**REVISED SCHEME DRAWING**

**1750 / 2B**

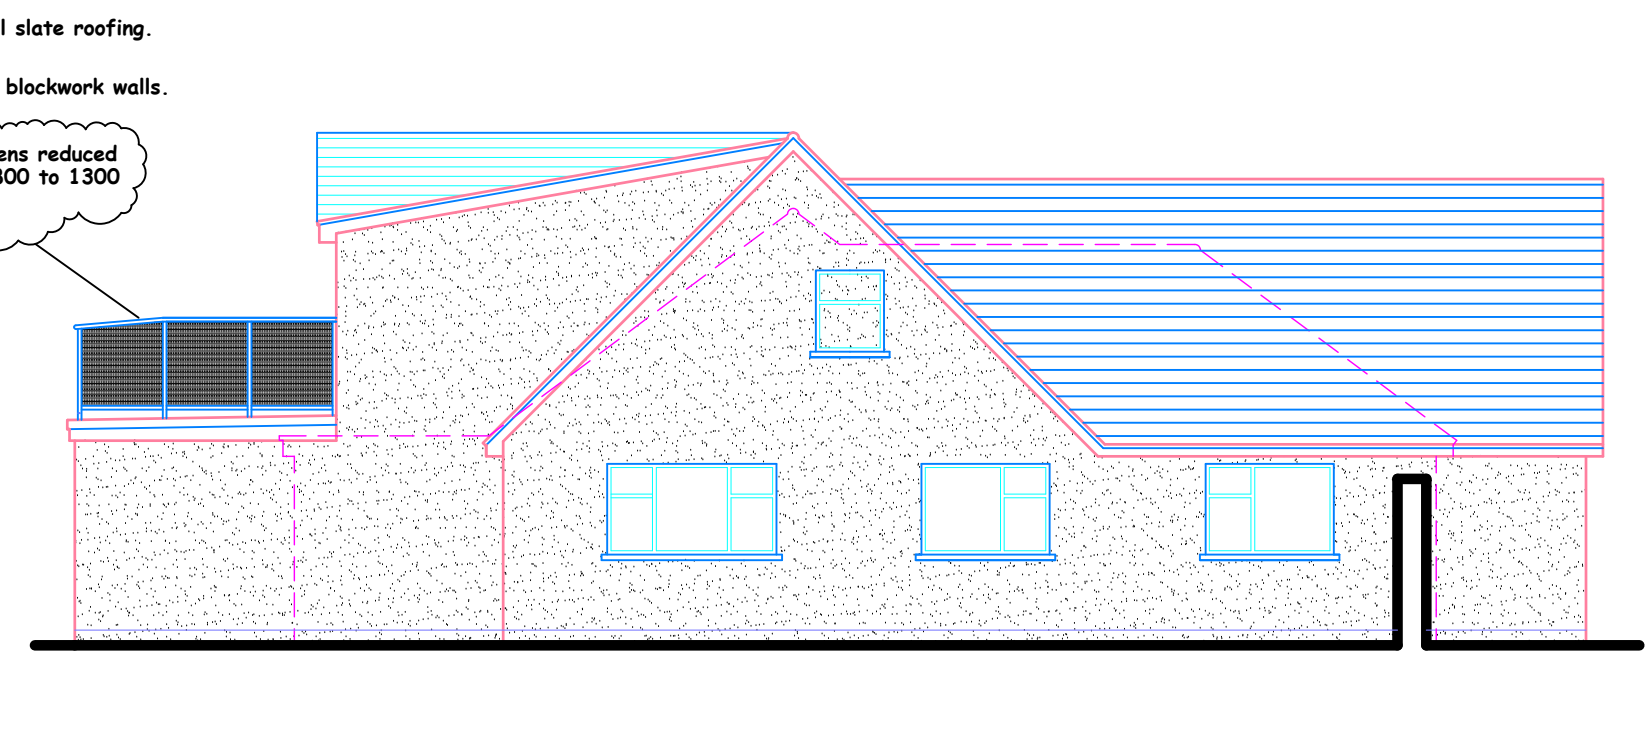
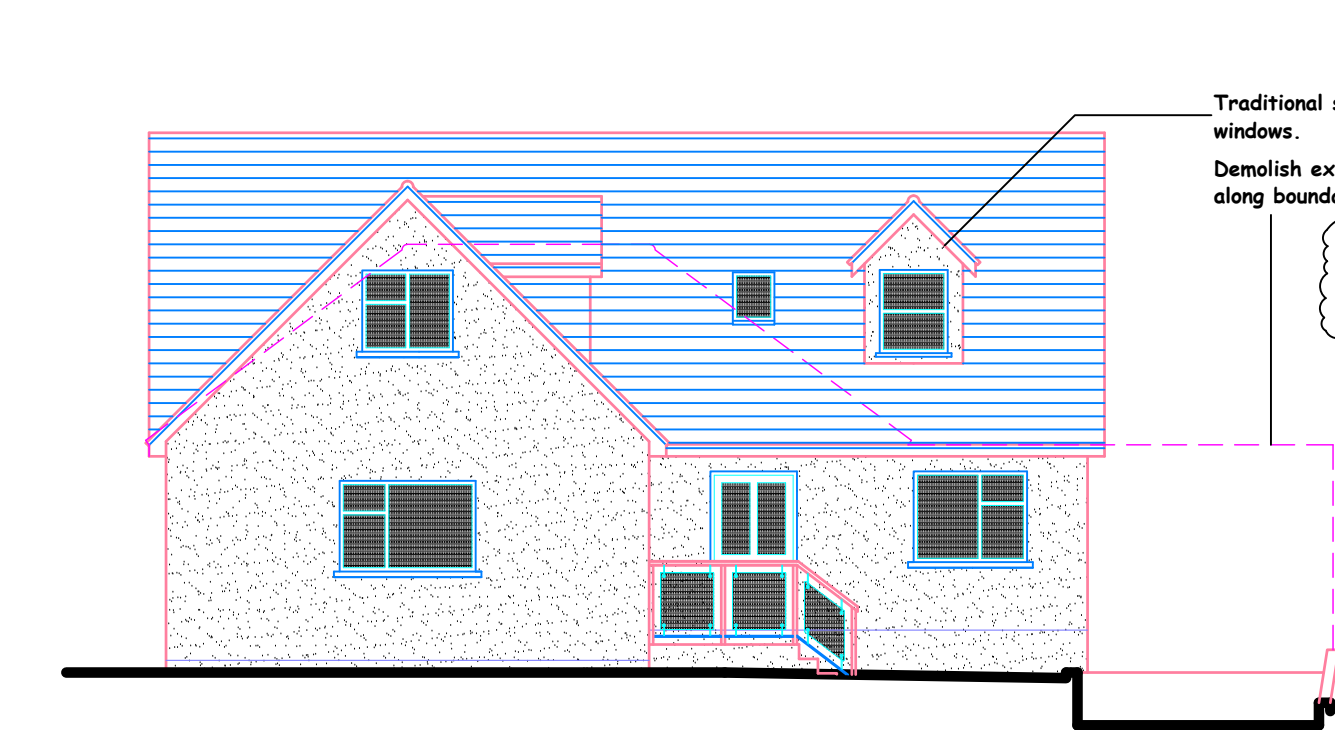
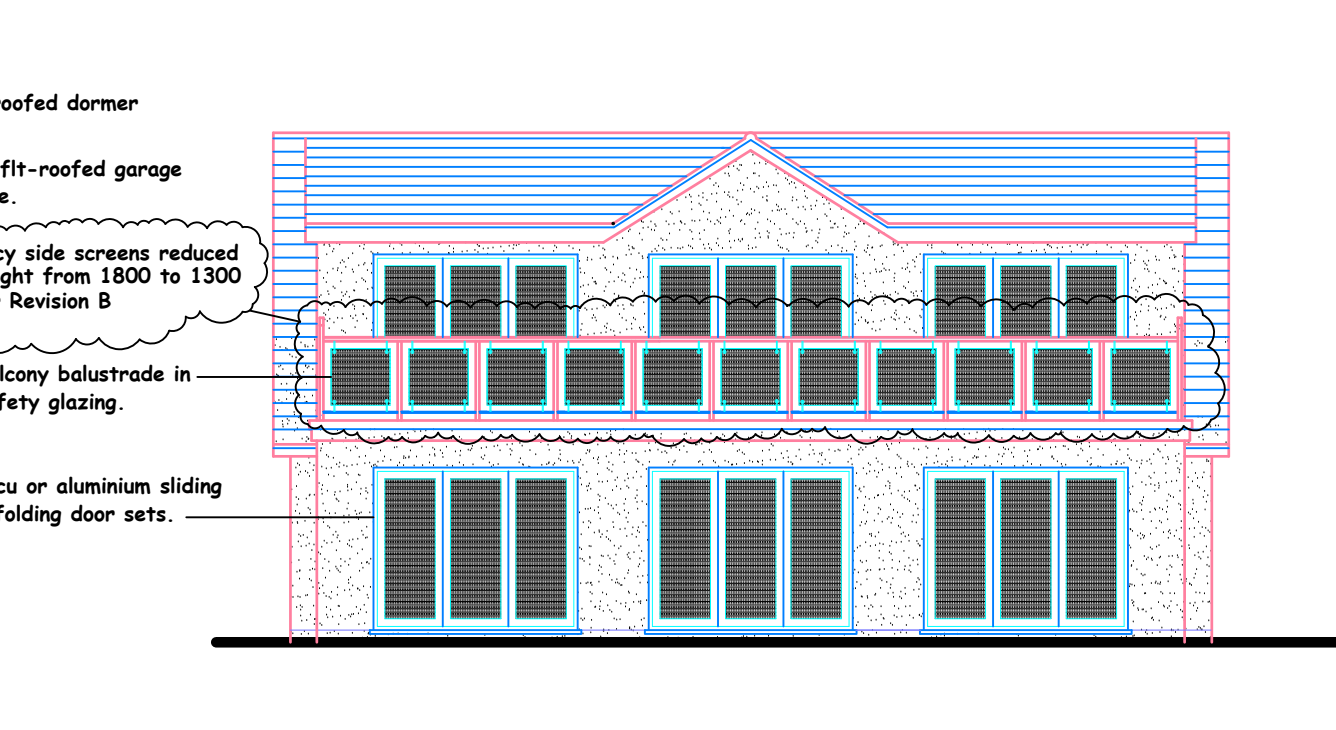
**REVISIONS**  
 A) Garage floor level dropped by 400mm to facilitate easier ramped vehicular access.  
 B) Side first floor near balcony privacy screens reduced in height from 1800 to 1300 due to potential loss of sight lines from neighbouring properties.
